CLARENCE CITY COUNCIL (PLANNING AUTHORITY) MEETING**MONDAY 21 NOVEMBER 2016****TABLE OF CONTENTS**

3.1 DEVELOPMENT APPLICATION D-2016/417 - 30 PASS ROAD, HOWRAH - NEIGHBOURHOOD SHOPPING CENTRE
(File No D-2016/417)**EXECUTIVE SUMMARY****PURPOSE**

The purpose of this report is to consider the application made for a Neighbourhood Shopping Centre at 30 Pass Road, Howrah.

A SHOPPING CENTRE ENRTY SIGNAGE

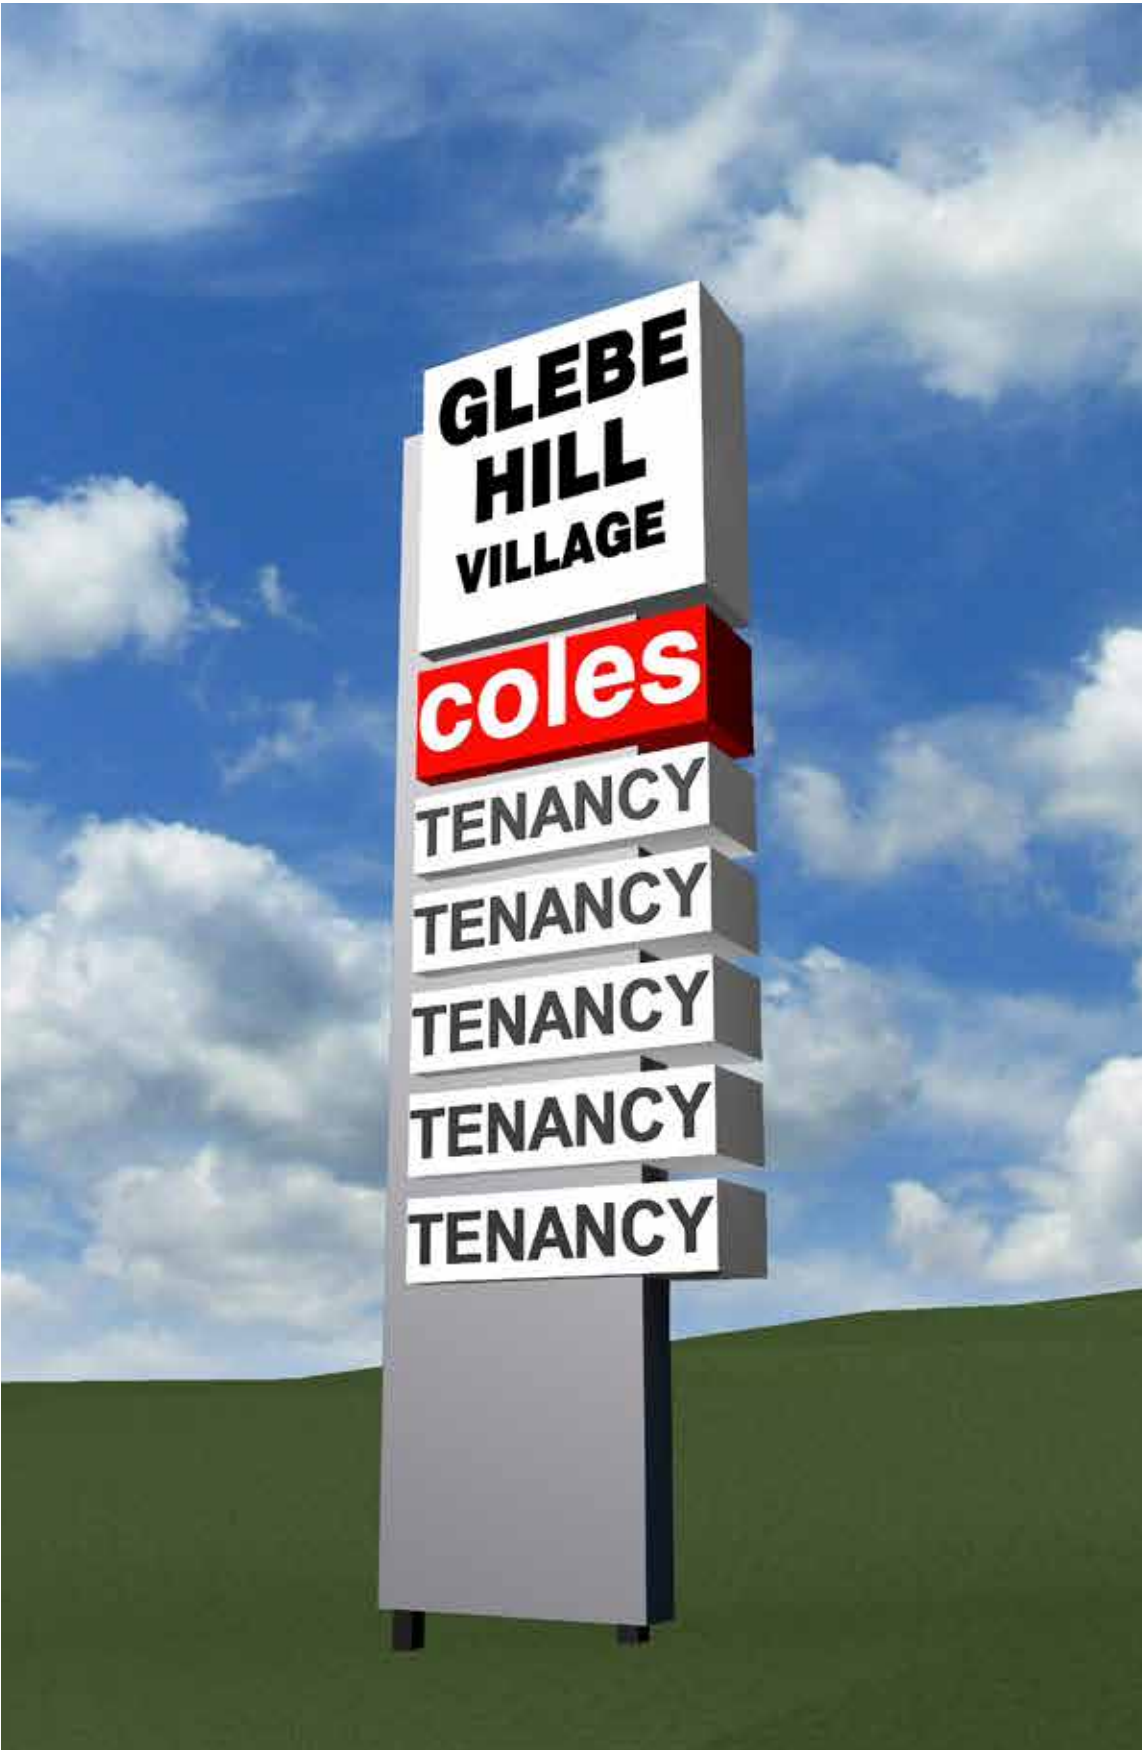
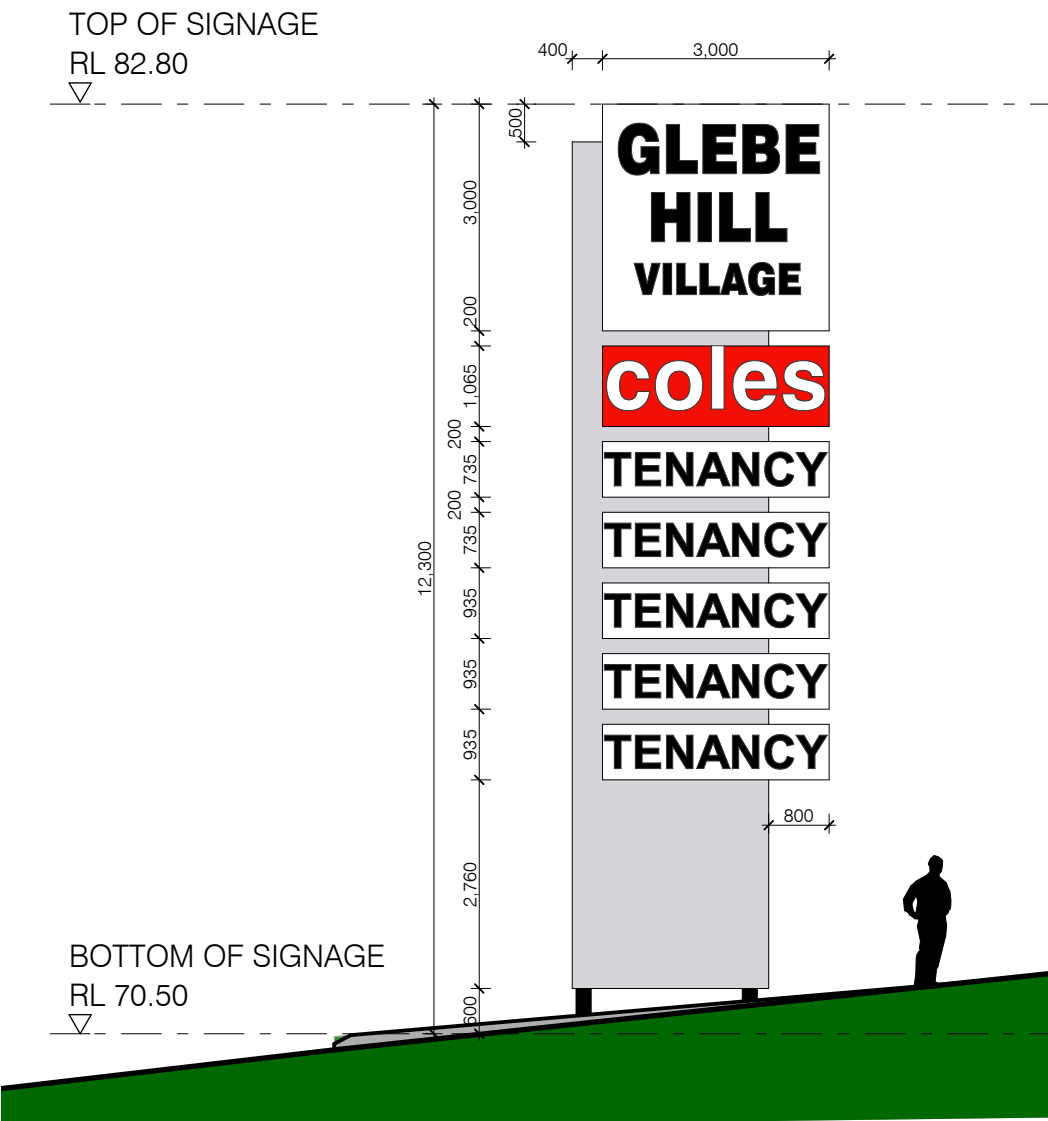
Clause	Standard	Acceptable Solution	Proposed
F13.7.2 A3	Siting and scale	Building Height The maximum height of buildings and signage is: 8.5m.	Does not comply - both Ground Based Panel Signs proposed would be 12.3m in height.

<p>The proposed Real Estate Sign at the same location appears also to dominate the streetscape and is remotely located to the shopping centre. After discussions with the applicant, the latter has accepted a reduced sign face (half of the originally proposed area) and for the height of the sign face to be lowered from 4m to 2.4m from natural ground level. An amended plans condition is proposed.</p>

(d) not result in loss of amenity to neighbouring properties;	<p>As discussed above, it is considered that there is potential for the Type A, Ground Based Panel Sign at the western entry to the slip road to dominate and potentially conflict with residential amenity in the vicinity of the site – and on that basis a reduction in height to 8.5m is considered an appropriate response. Similarly, the reduced sign face and overall height of the real estate sign will address the performance criterion.</p>

2. GEN AP3 – AMENDED PLANS [the “Shopping Centre Entry Sign” located at the intersection of the South Arm Highway and the slip road reduced in height to not exceed 8.5m above natural ground level and a lease sign also in the same location to be reduced to 4m x 6m per face and for each face to be not greater than 2.5m above natural ground level].
